Product Change Notification: PCN-22-136415

A91 - Circular Commercial Connectors COVER 90DEG A91 - Circular Commercial Connectors ABDECKAPPE 90GRD

The Industrial and Commercial Transportation business unit of TE Connectivity is making a minor drawing change to show the views of the caps with mold bumps and the new date clock placement for the product drawings listed below. 96577 965783

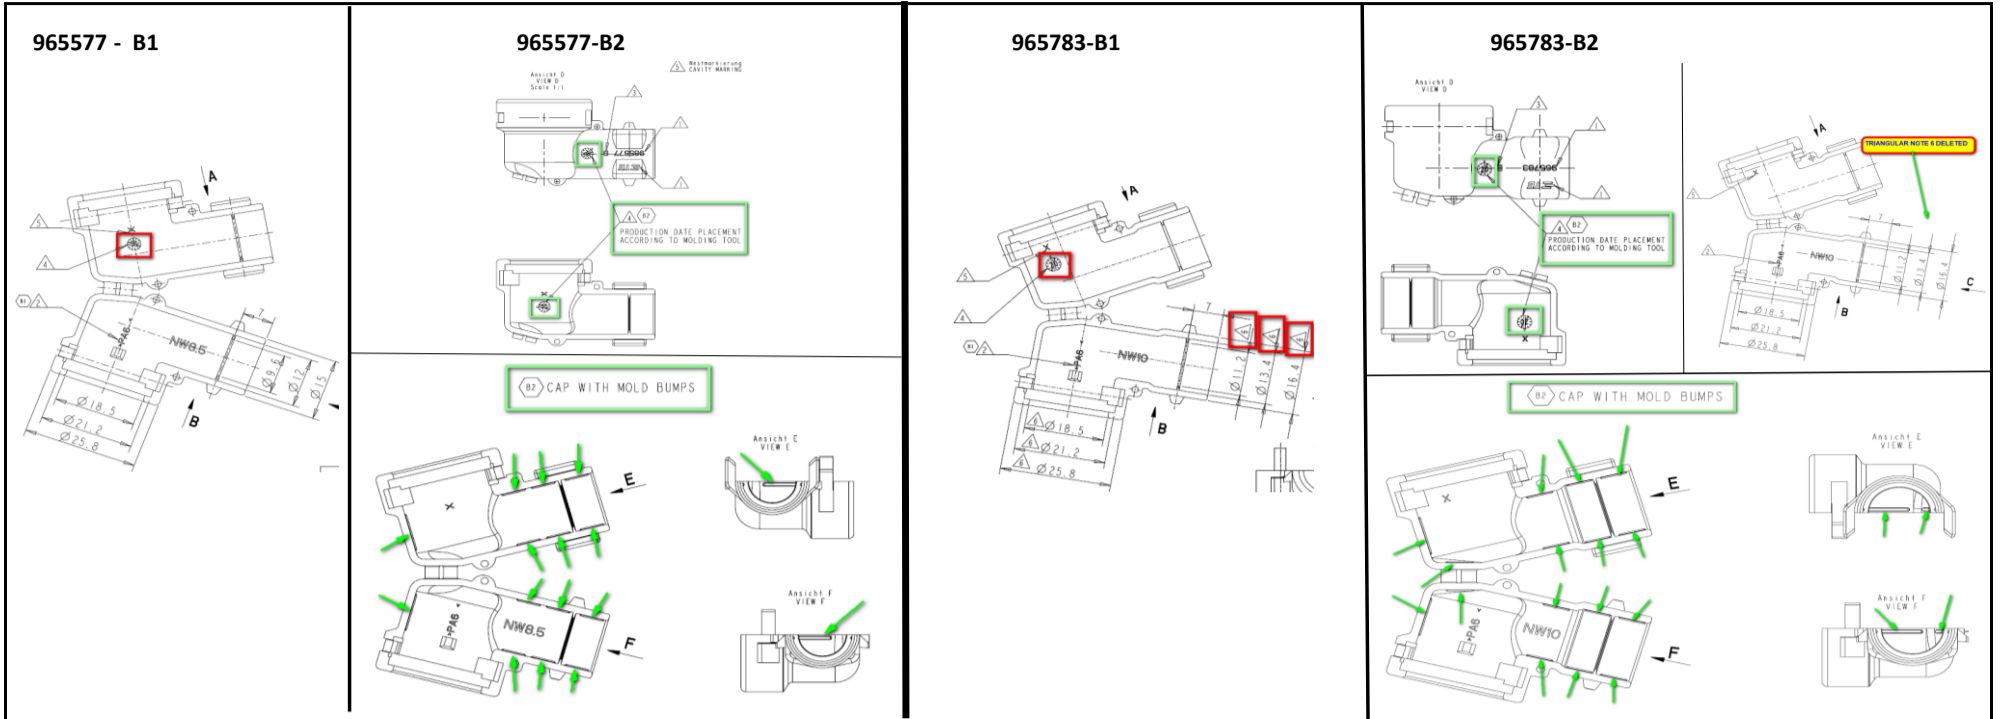
| x | Potential Impact for Customer | x | Product Type | x | Change Type | x | Kind of Change | x | Change Feature | Remark / Free text |
|---|-------------------------------|---|----------------------------------|---|------------------------|---|----------------|---|----------------|---|
| x | Revision adapted | x | CAPS/COVERS AND COVER ASSEMBLIES | x | No Form, Fit, Function | x | Drawing | x | Drawing Change | Mold bumps added along with new date placement. |
